## VCR / CAMERA SERVICE BULLETIN NO: 68A

MODELS: M-458, M-468, M-657, M-658,  
M-668, M-758

SUBJECT: S-Soft Brake Lever (Corrected Part Number from # 68)

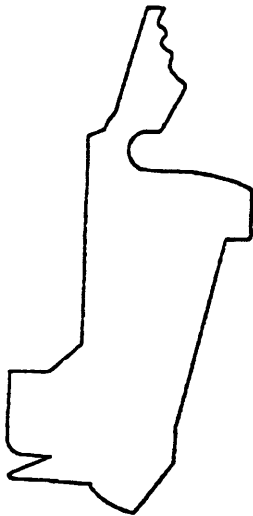
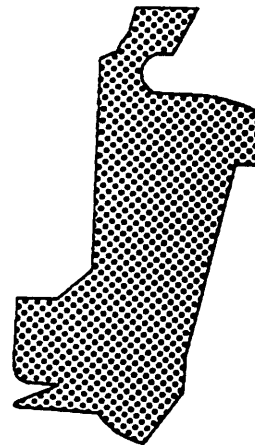
**Symptom:** Will not play due to loading malfunction.

**Corrective Action:** Replace the soft brake lever K128 with the new black colored one.

Location	Part No.	Vendor	Description
K128	70363026	J	Lever, S-Soft Brake
